CALPINE CORPORATION

**RE: Response to Request for Additional Information
Deer Park Energy Center LLC
Deer Park, Harris County, Texas**

On behalf of Deer Park Energy Center LLC, Calpine Corporation is hereby submitting this response to the October 28, 2011 request for additional information for the pending Deer Park Energy Center application for a Prevention of Significant Deterioration (PSD) air quality permit for greenhouse gas (GHG) emissions. The questions asked in the letter are duplicated below followed by a response:

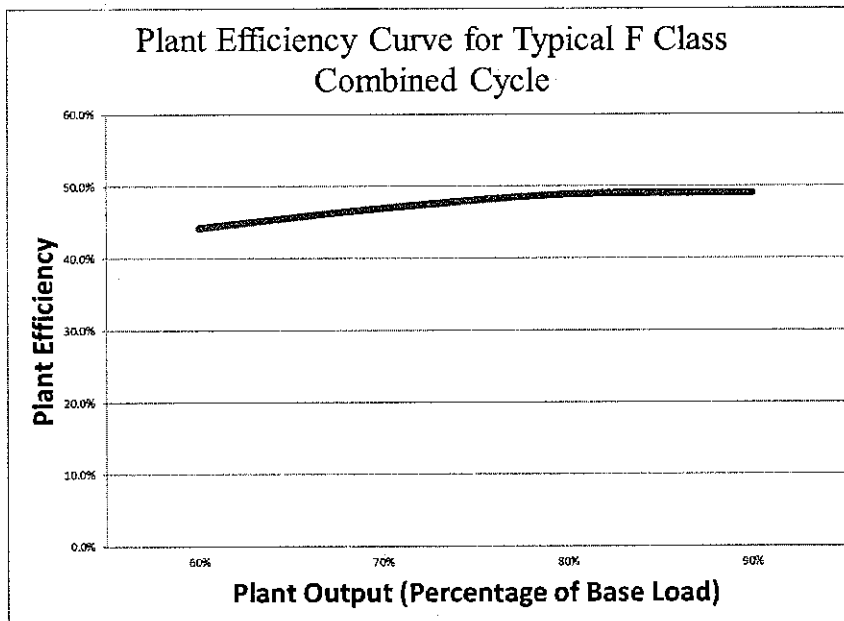
4. *Please provide a basis and documentation to support the base heat rate compliance margins listed on page 40 of the permit application.*

To determine an appropriate heat rate limit for the permit, the following compliance margins were added to the base heat rate limit:

- A 3.3% design margin reflecting the possibility that the constructed facility will not be able to achieve the design heat rate.
- A 6% performance margin reflecting efficiency losses due to equipment degradation prior to maintenance overhauls.
- A 3% degradation margin reflecting the variability in operation of auxiliary plant equipment due to use over time.

Design and construction of a combined-cycle power plant involves many assumptions about anticipated performance of the many elements of the plant, which are often imprecise or not reflective of conditions once installed at the site. As a consequence, the

facility also estimated an "Installed Base Heat Rate", which represents a design margin of 3.3% to address such items as equipment underperformance and short-term degradation.

To establish an enforceable BACT condition that can be achieved over the life of the facility, the permit limit must also account for anticipated degradation of the equipment over time between regular maintenance cycles. A 48,000-operating-hour degradation curve provided by Siemens reflects anticipated recoverable and non-recoverable degradation in heat rate between major maintenance overhauls of approximately 5%. The degradation curves describe the amount of "recoverable" and "non-recoverable" degradation. The former includes degradation that can be recovered through compressor water washing, filter changes, instrumentation calibration and auxiliary equipment maintenance. The latter includes degradation that cannot be restored upon a maintenance overhaul.

The manufacturer's degradation curves only account for anticipated degradation within the first 48,000 hours of the gas turbine's useful life; they do not reflect any potential increase in this rate which might be expected after the first major overhaul and/or as the equipment approaches the end of its useful life. Further, the projected 5% degradation rate represents the average, and not the maximum or guaranteed, rate of degradation for the gas turbines. Therefore, Deer Park Energy Center proposes that, for purposes of deriving an enforceable BACT limitation on the proposed facility's heat rate, gas turbine degradation may reasonably be estimated at 6% of the facility's heat rate.
